**AQUATIC EFFECTS MONITORING PROGRAM ANNUAL 2019
REPORT – PLAIN LANGUAGE BRIEFING AND TECHNICAL
REVIEW COMMENTS**

Technical Memorandum # 367-21-01

Environmental Monitoring Advisory Board (EMAB)
P.O. Box 2577
Yellowknife, NT
X1A 2P9

January 22, 2021

Figure 1. Phytoplankton biomass: 2019 (Figure 3-14, Appendix VIII, p. 39; Golder 2020).

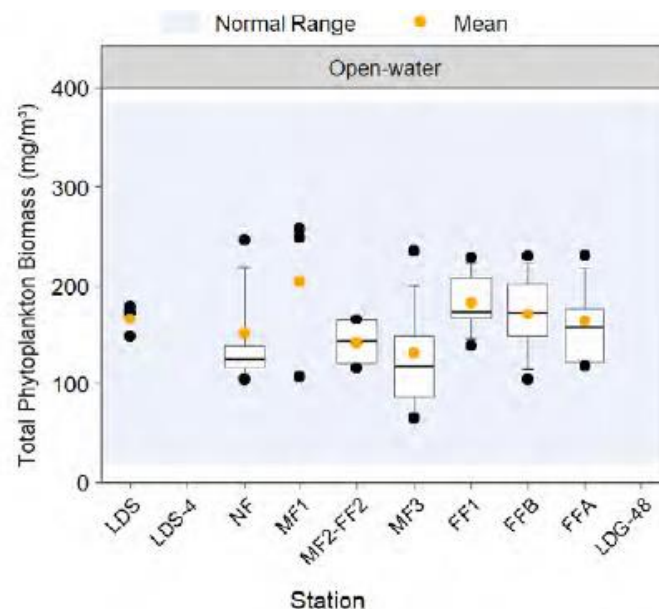
Additionally, the spatial patterns for phytoplankton biomass and chlorophyll *a* are inconsistent which further suggests the biomass results may not be accurate (see Figures 1 and 2 below).

APPENDIX VIII, Eutrophication Indicators Report, Section 3.6.3, Results, Chlorophyll <i>a</i> and Phytoplankton and Zooplankton Biomass, p. 38-39	The phytoplankton biomass data indicate relatively similar densities between areas, but lower densities than the normal range (Figure 3-14). The spatial pattern differs from chlorophyll <i>a</i> (Figure 3-13) which, along with the information presented regarding sample integrity issues, suggests the phytoplankton biomass data may be erroneous. This is further suggested by comparison on spatial patterns for chlorophyll <i>a</i> (Figure 3-13) and zooplankton (Figure 3-15).	<p>Compare phytoplankton counts for 2019 to results from previous years, including overall counts and counts for major groups.</p> <p>Compare chlorophyll <i>a</i> results, in conjunction with biomass and cell counts for phytoplankton, from 2019 to previous years to further examine the validity of the biomass data for 2019.</p>

Recommendation: Compare phytoplankton counts for 2019 to results from previous years, including overall counts and counts for major groups.

Compare chlorophyll *a* results, in conjunction with biomass and cell counts for phytoplankton, from 2019 to previous years to further examine the validity of the biomass data for 2019.
